Access Compliance Report

Public Rights-of-Way

Intersection ID: 10030304	Main Street: LEES_COURT_ST	Cross Street: N/A	Location: SE
ADA ID: A5902F78BDA6	Ramp Type: PerpDiag	Initial Pass/Fail: Fail	Overall Compliance: No
Codes/Mitigation Info/Possible Solution		Field Measurements/Component Compliance	
Severity Score: 8.75

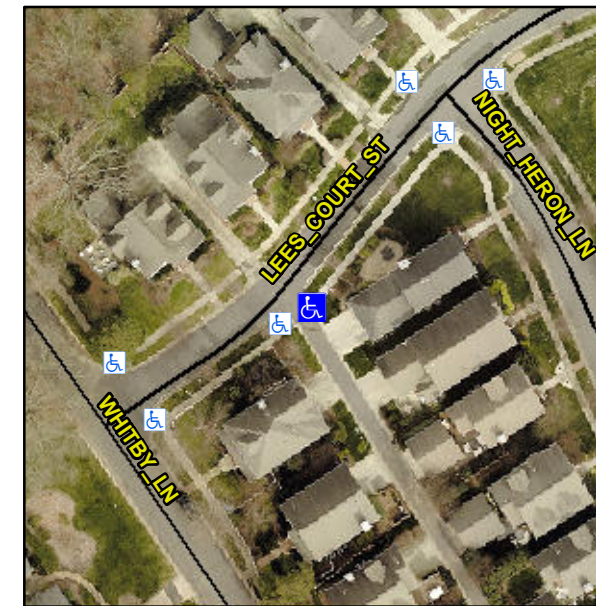
Compliance	Description	Data	Compliance	Description	Data
N/A	Ramp Length (in)	55.0	Yes	Ramp Slope (%)	7.5
No	Ramp Width (in)	41.0	Yes	Ramp XSlope (%)	2.0
N/A	Flare Type LT	N/A	N/A	Flare Type RT	N/A
N/A	Flare Slope LT (%)	N/A	N/A	Flare Slope RT (%)	N/A
N/A	Flare Traversable LT?	N/A	N/A	Flare Traversable RT?	N/A
N/A	Landing Length (in)	N/A	N/A	DWS Provided?	N/A
N/A	Landing Width (in)	N/A	N/A	DWS Contrast?	N/A
N/A	Landing Slope (%)	N/A	N/A	DWS Length (in)	N/A
N/A	Landing X Slope (%)	N/A	N/A	DWS Full Width?	N/A
N/A	Landing Curb? (Y/N)	N/A	N/A	DWS Offset (in)	N/A
N/A	Shared Landing?	N/A			
N/A	Gutter Ponding?	N/A	N/A	Gutter Slope (%)	N/A
N/A	Gutter Lip Ht (in)	N/A	N/A	Gutter X Slope (%)	N/A
N/A	Painted X Walk1?	No	N/A	Painted X Walk2?	No
	X Walk 1 Direction	To N		X Walk 2 Direction	To SW
N/A	X Walk 1 Width (in)	N/A	N/A	X Walk 2 Width (in)	N/A
	X Walk 1 Slope (%)	2.0		X Walk 2 Slope (%)	2.3
	X Walk 1 X Slope (%)	3.7		X Walk 2 X Slope (%)	0.8

N/A	Ramp inside XWalk1?	N/A	N/A	Ramp inside XWalk2?	N/A
	Road Slope (%)	0.2	N/A	Clear Space?	N/A
	Road X Slope (%)	3.7	N/A	Clear Space to XWalk (in)	N/A
N/A	Any Obstructions?	N/A	N/A	Storm Grate/Utility Hazard?	N/A
	Obstruction Type			Storm Grate/Utility Type	
		N/A			N/A
			Yes	Surface Condition? (G/P)	Good

Remove & Replace Curb Ramp With Two New Directional Ramps or Equivalent.
